BACKGROUND INFORMATION

ANALYSIS OF THE DIRECTOR – DESIGN REVIEW

The Early Design Guidance meeting took place on November 21, 2005, in Room 106 of the University Heights Community Center. The applicant submitted a complete Master Use Permit (MUP) application on January 31, 2006. The Recommendations meeting took place on February 22, 2006, in Room 22 of the Meadowbrook Community Center. This report summarizes the design review findings. For a more complete overview of the Board's Early Design Guidance and Recommendations, please refer to the project file.

Figure 1. Local topography

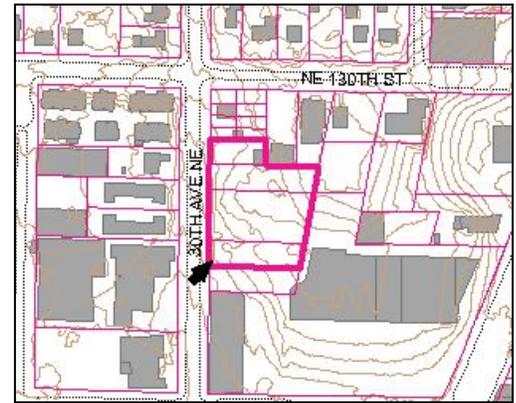
from northeast to southwest, about 10' in all (see Figure 1). No portion of the site is designated as Environmentally Critical Area on City maps. There are existing trees on the site, including a hemlock measuring 30" diameter at breast height (dbh), a cottonwood (24" dbh), some cedars (12-24" dbh), and a Douglas fir (18" dbh). There is an existing curb and sidewalk, with a somewhat informal landscape buffer between the sidewalk and street.
